**Baffinland Iron Mines Corporation  
Mary River Expansion Project  
Construction Summary Report: Stockyard #1 Expansion**

2019-08-08	0	Approved for Use	G. Peace	R. Bader	M. Coakley	D. Henkelman
Date	Rev.	Status	Prepared By	Checked By	Approved By	Approved By
HATCH						Client

## **As-built Drawings**

SITE WIDE  
STANDARD DRAWING  
EARTHWORKS & DRAINAGE DETAILS

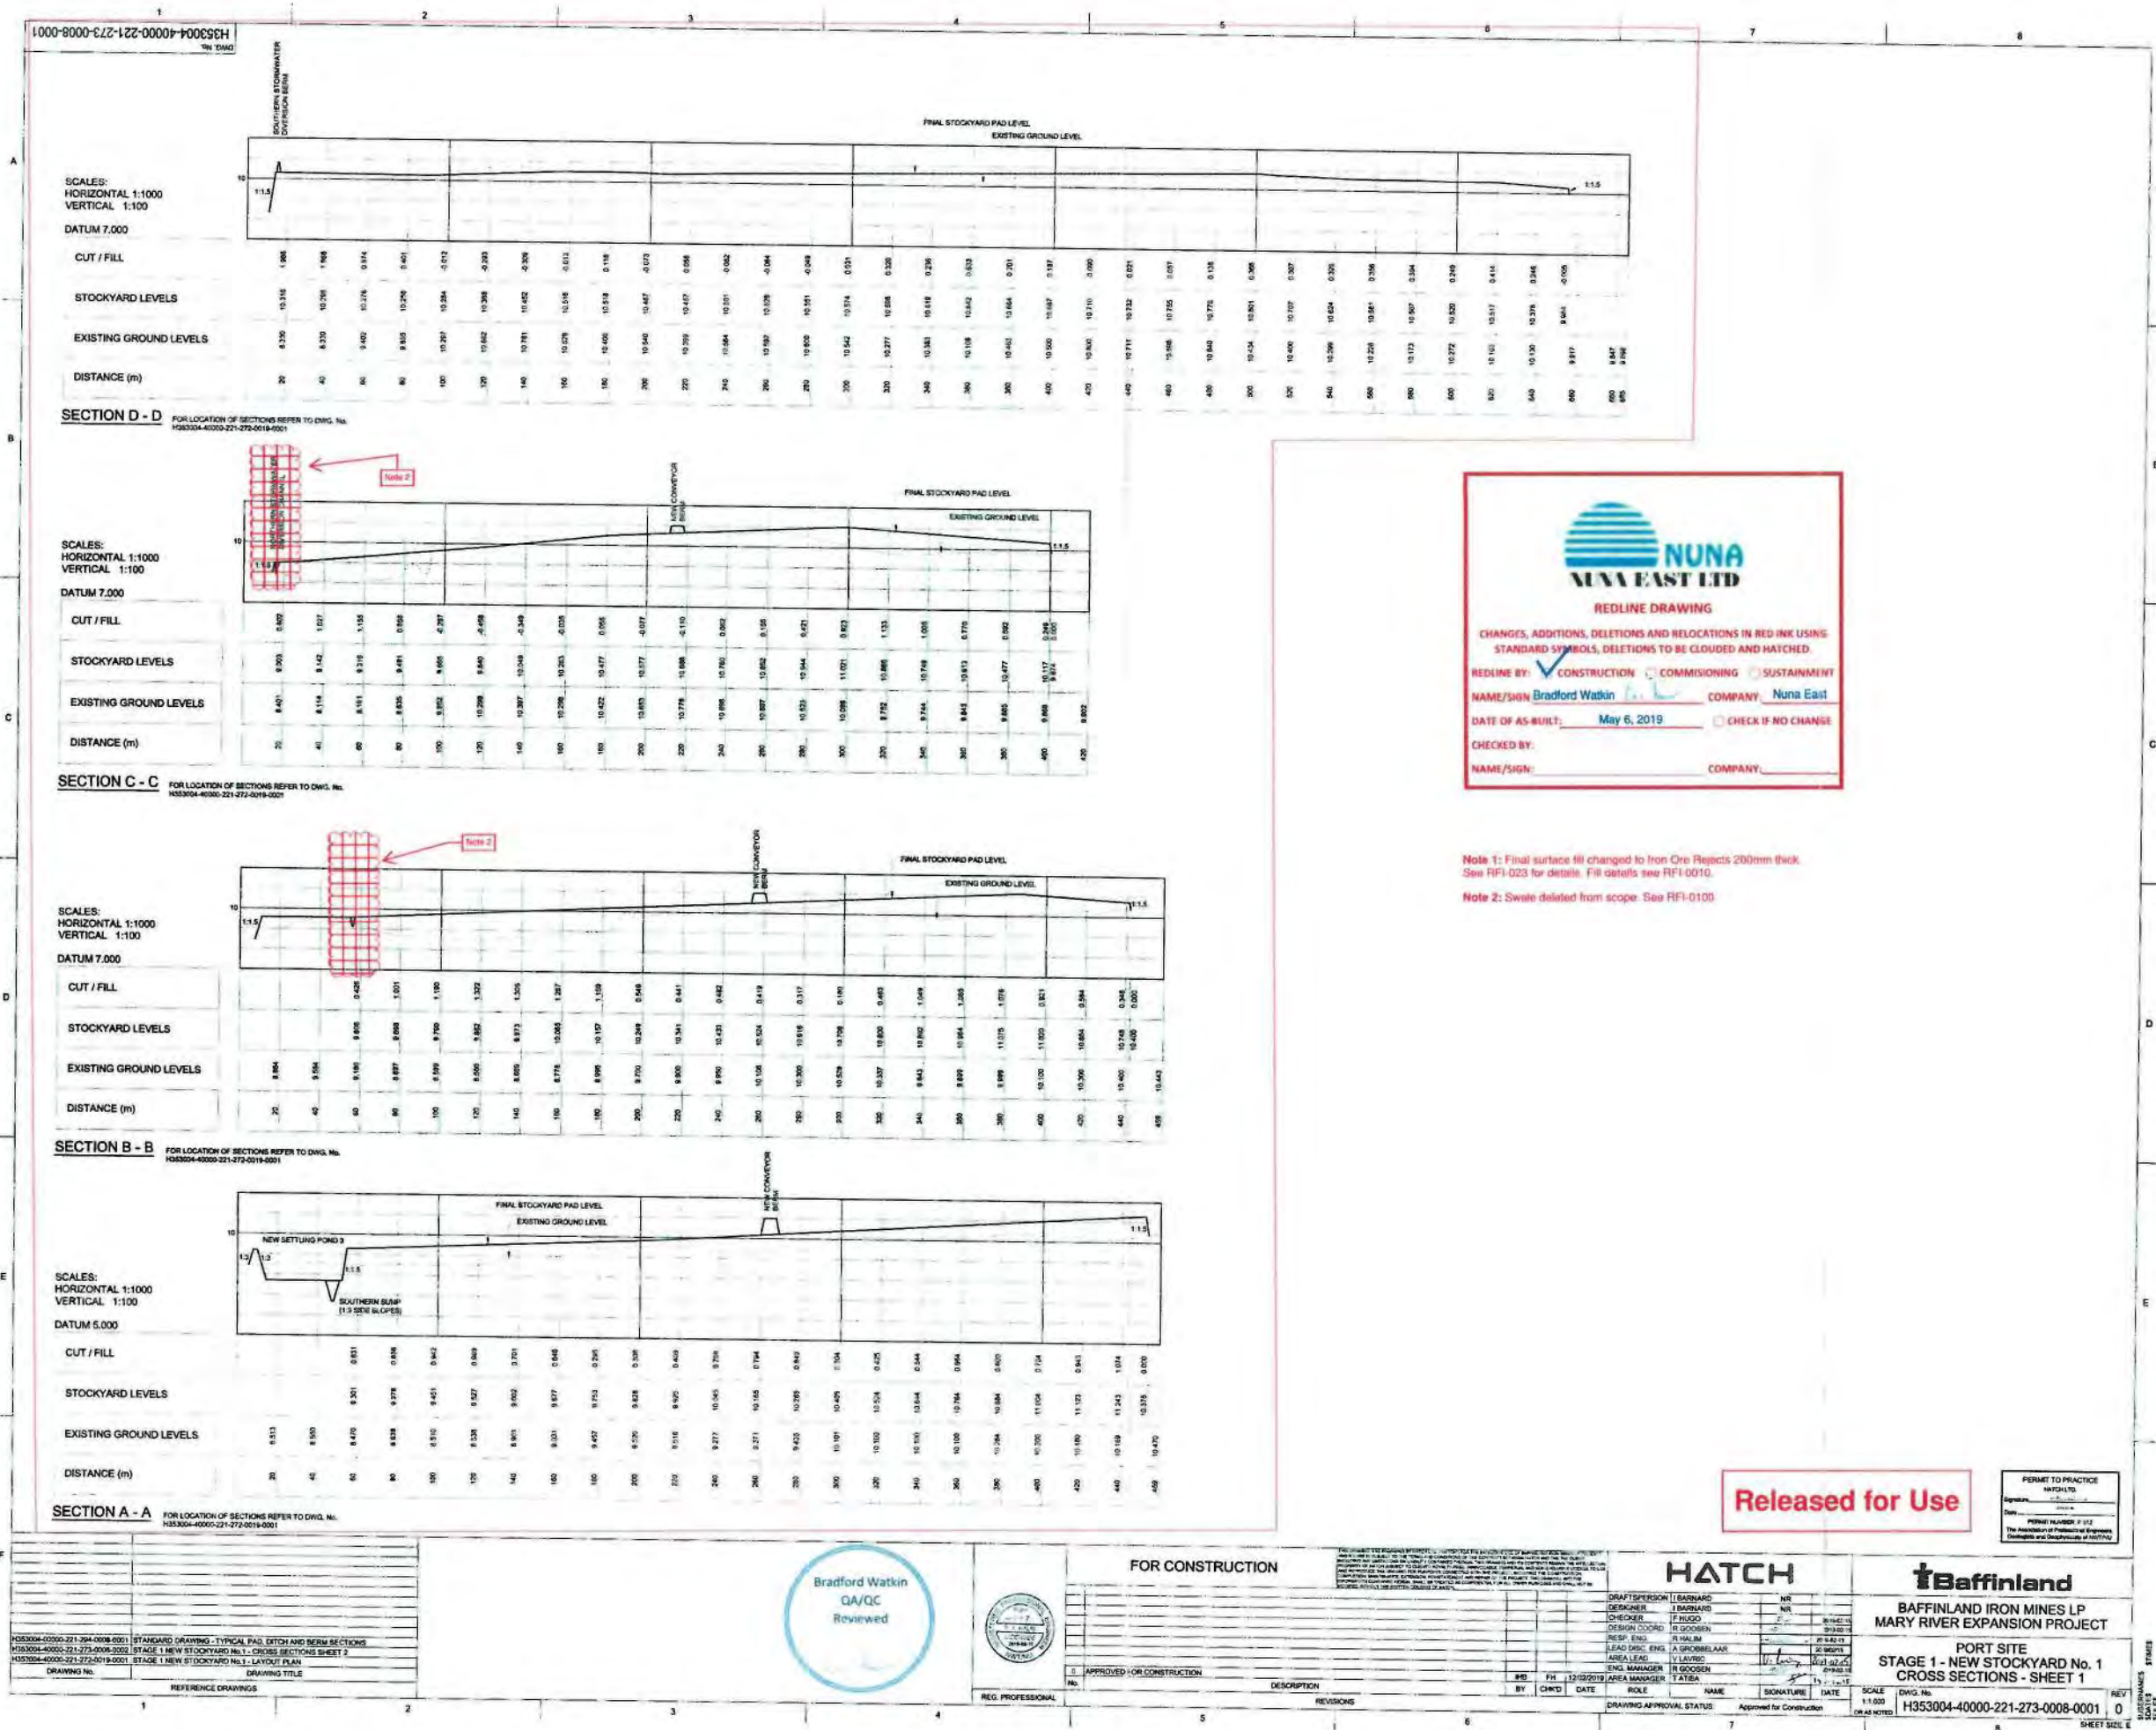
Note 1: Final surface fill changed to Iron Ore Rejects 200mm thick.  
See RFI-023 for details. Fill details see RFI-0010.

**Request for Information**

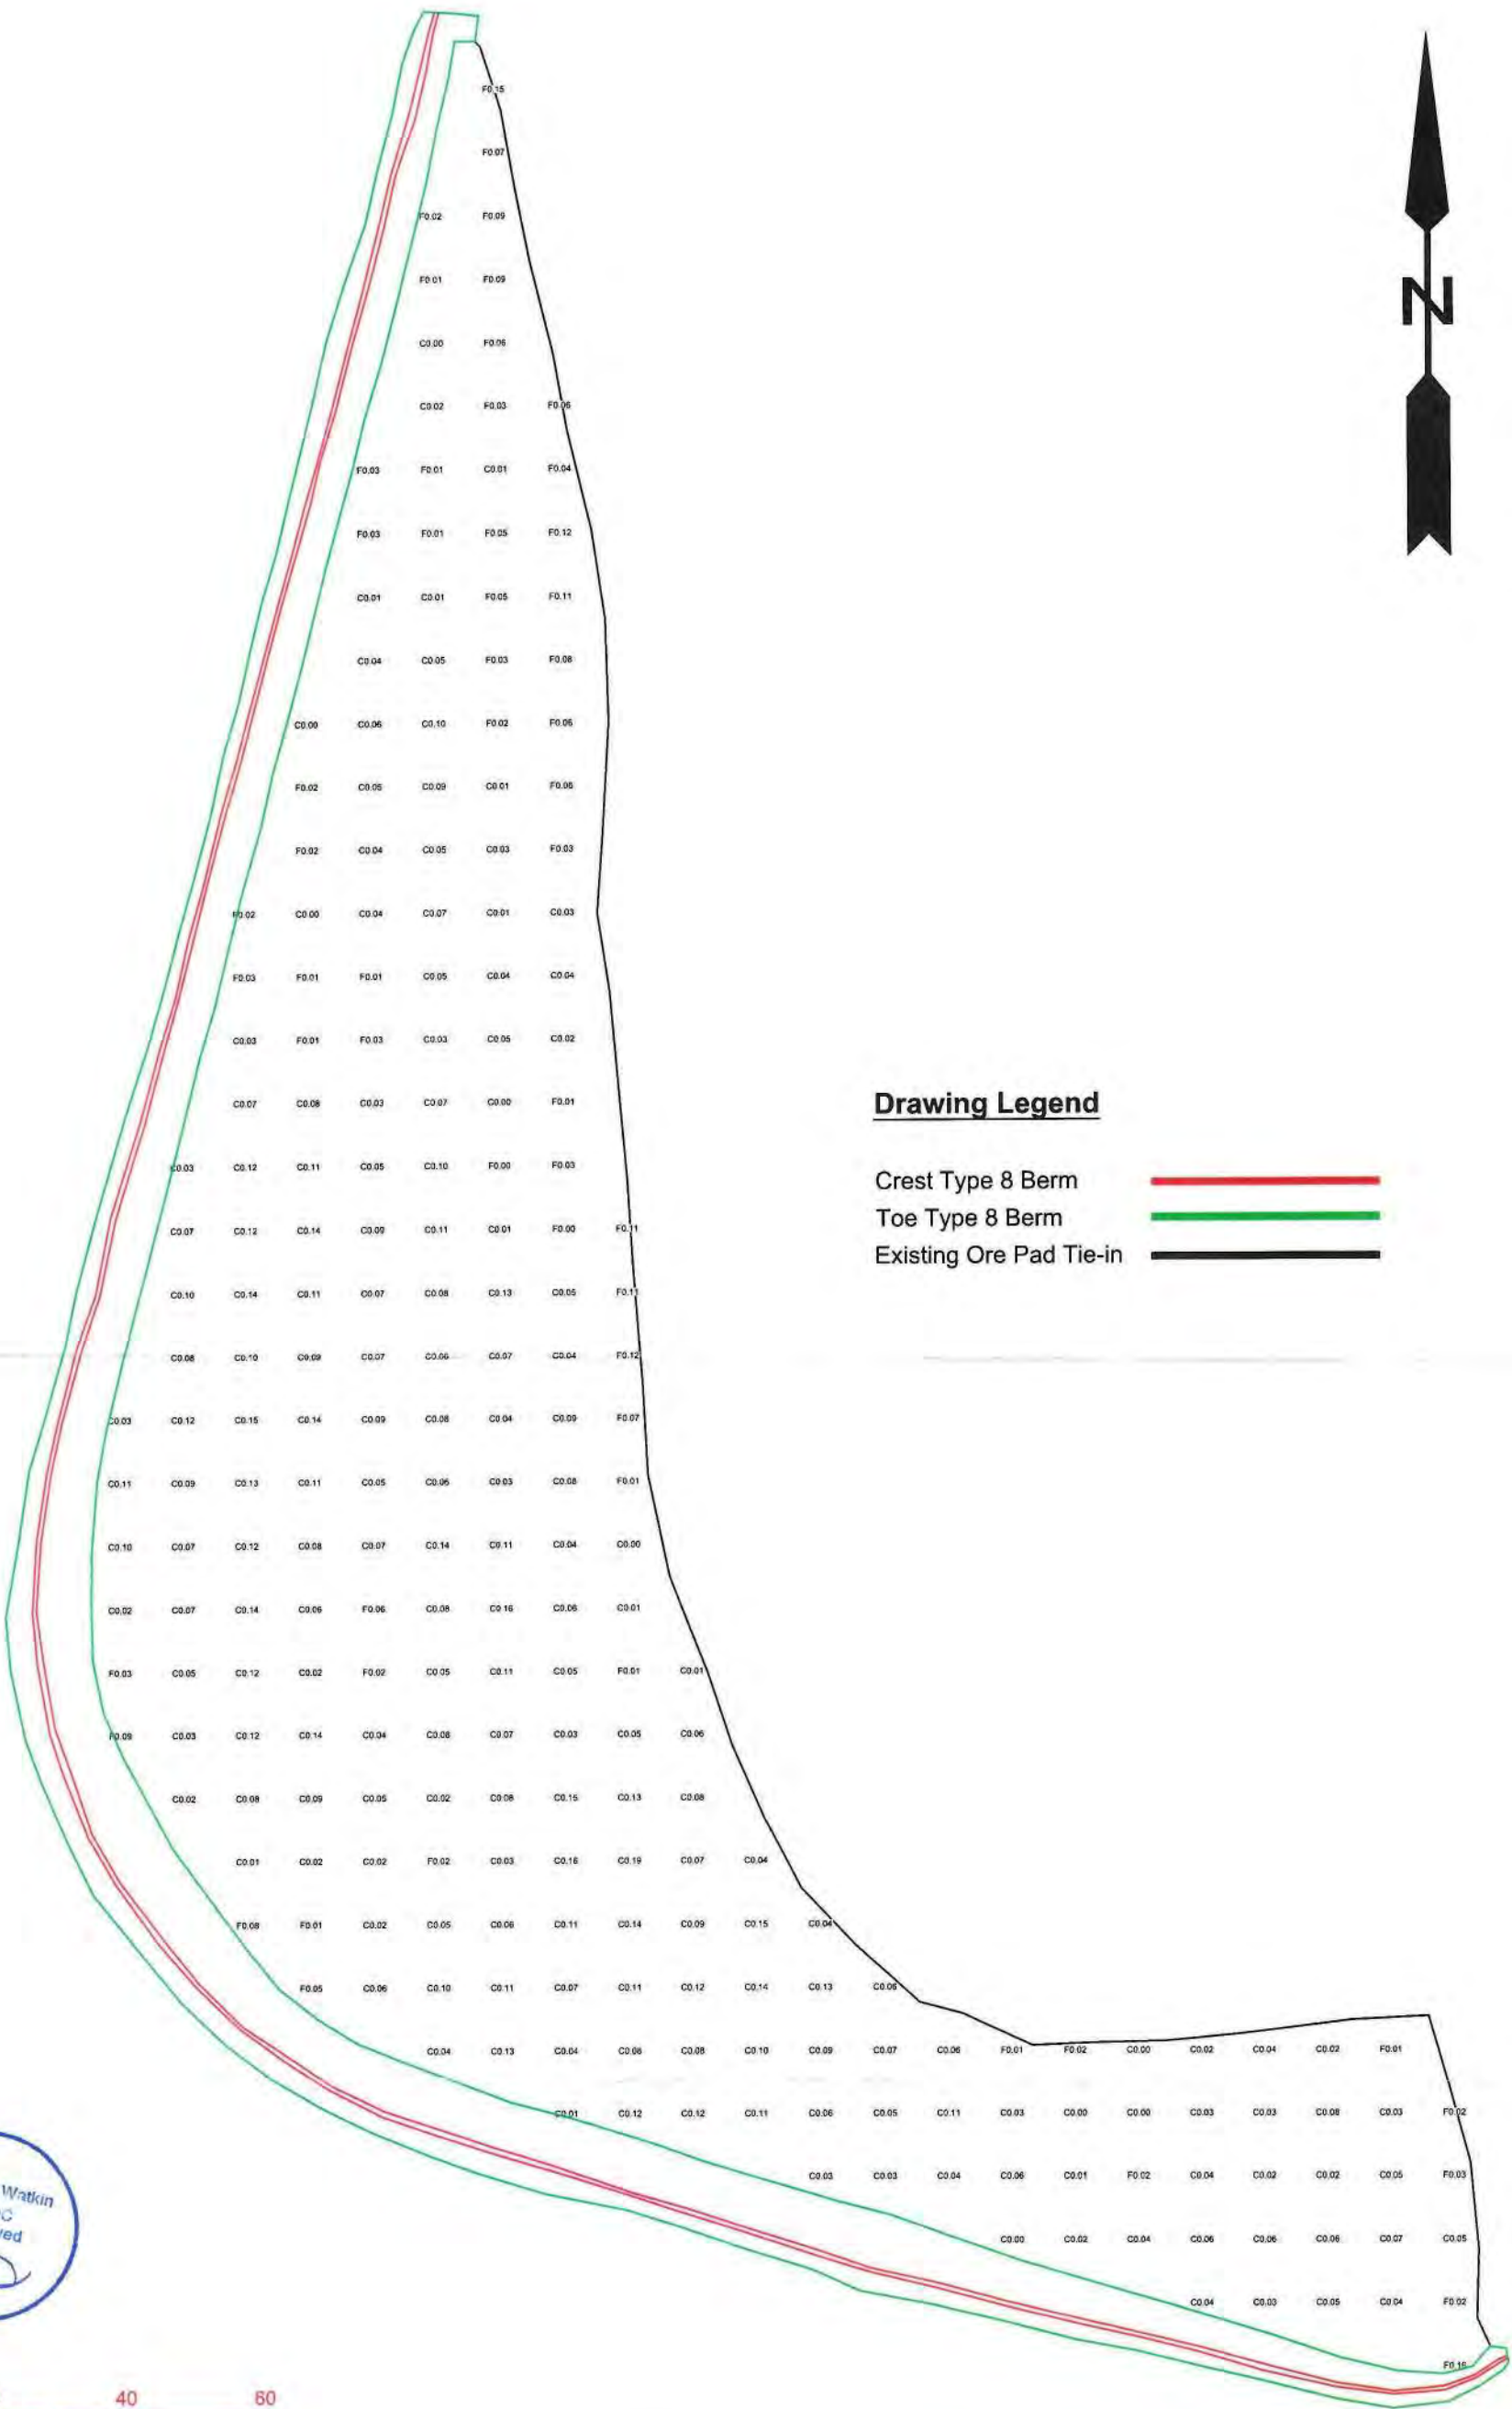
1. In order to follow the Typical detail (H353004-00000-221-294-0002-0001), additional cut volumes of 41007M3 will be required. Is Nuna to construct the pad as per the typical detail (600mm of Type 12, 300mm of Type 8, and 100mm of Type 5) and move additional material, or will the pad design be altered.
2. Nuna will require instruction for a dump location for cut volumes from the pad footprint.
3. There is ice located within the footprint of the proposed expansion. Please identify a dump location for the ice.
4. The issued drawings describe a swail being constructed for water management. DWG files issued to survey for layout include a ditch. We require clarification as to which is correct and require the correct design to be issued to Nuna/survey.

1. As per the typical detail the following minimum layerworks are required below the finished final level of the terrace: 100mm Type 5 and 300mm Type 8. Where fill is required to achieve this min 400mm layerworks and more fill than 400mm is required, general fill must be used. General fill comprises of a combination of Type 8 and Type 12. Where the general fill depth exceeds 600mm (Below the 400mm minimum), Type 12 must be used to makeup the fill. Where the fill depth is less than 600mm below the min 400mm, Type 8 must be used. Where excavation is require to get to the final design terrace levels, a maximum over excavation of 400mm below the final surface is required and NOT 1000mm. This will reduce the required cut volumes.

2. The dump location will be one of the historical borrow pits at Milne Port. Contact Hatch on site to finalize.
3. The ice can be taken to the established snow dump. Hatch on site can show this location.

4. The only ditch in this area must be the existing ditch, to be filled in where new earthworks are being constructed and tied into at the endpoint of the pad as per the typical detail for the tie in point on the drawing. For details use the 3D model of the Stockpile No 1 Expansion. The DWG file should not be used.
